249 Valve Cap and Shaft Change

Chelsea has made a running change to the design of the 249 valve cap and output shaft that will improve performance and durability. The New Design requires a new shaft and valve cap part number. The old and new designs are NOT interchangeable. Both the valve cap and shaft MUST be changed at the same time.

Old Style - 329614X

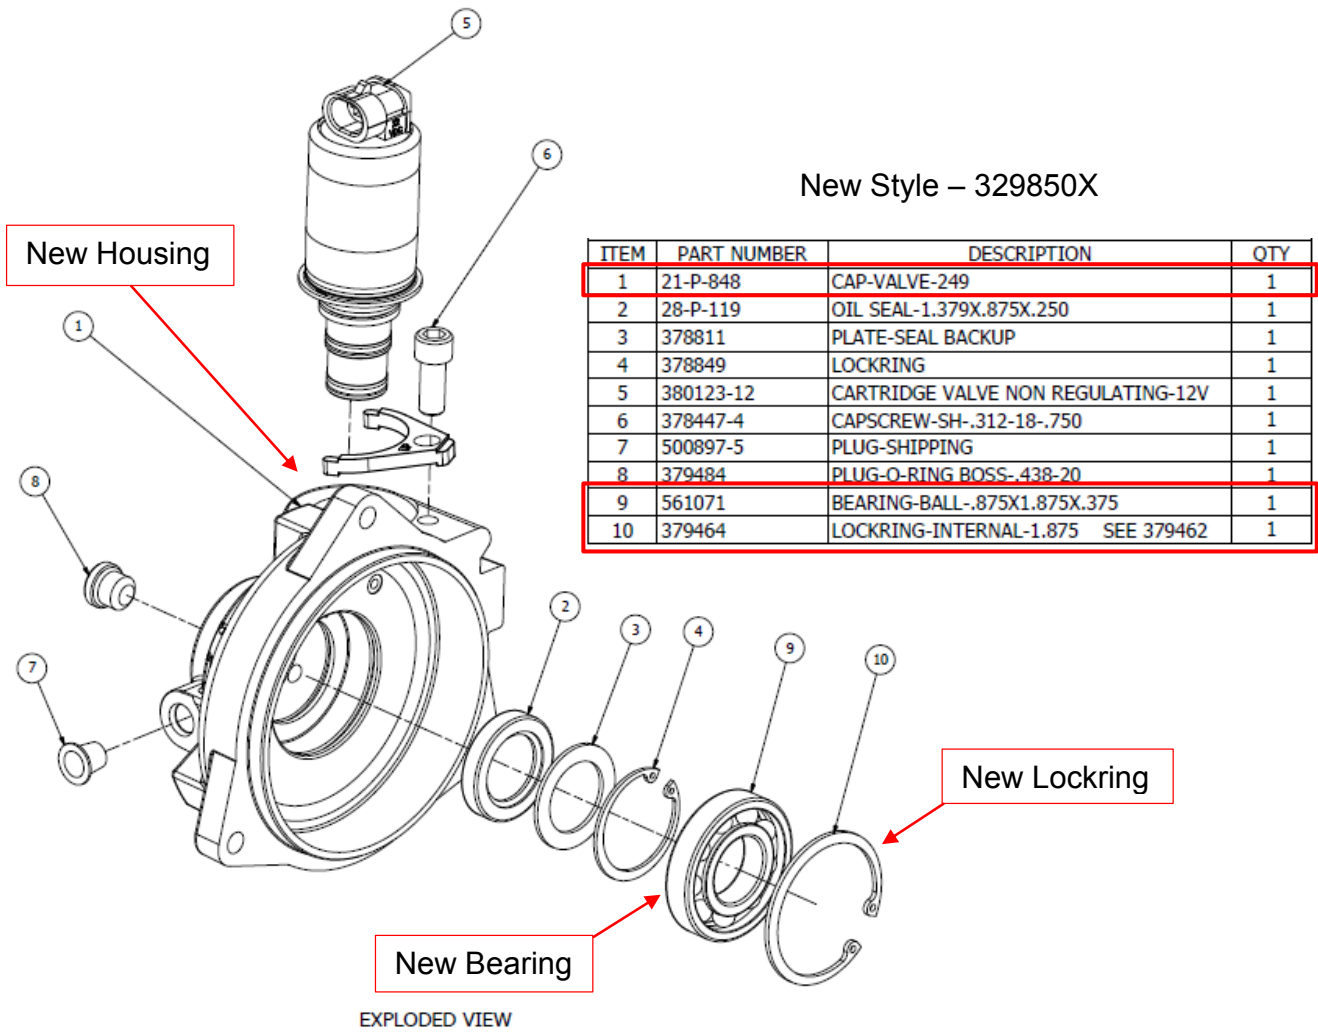
The New Design includes the following changes:

1. New Bearing – larger ID and OD
2. New Housing – modified for new bearing
3. New Lockring – to retain the bearing.
4. New Shaft – required due to the new bearing ID.
